# ◀ IMPORTANT UPDATE ▶

DATE	TOPIC
September 10, 2021	<ul style="list-style-type: none"><li>A warning about not disturbing the vehicle while it is reprogramming has been added.</li></ul>

**TECHNICAL INSTRUCTIONS**  
**SAFETY RECALL 21TA04**  
**POTENTIAL INCREASED BRAKING DISTANCE**  
**CERTAIN 2020 - 2021 MODEL YEAR SUPRA VEHICLES**

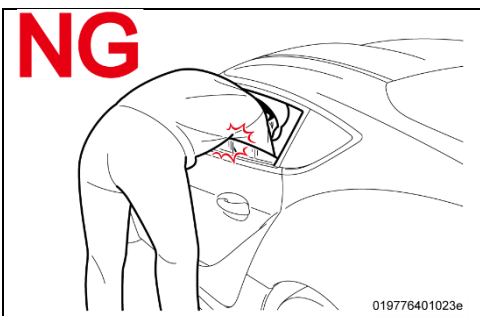
The programming could take a long time. **DO NOT** disturb the vehicle until it's finished reprogramming. Refer to the progress bar at the top of the screen to confirm the status. If you truly believe there is some problem with the vehicle reprogramming, **DO NOT DISTURB THE VEHICLE**, call TAS for assistance.
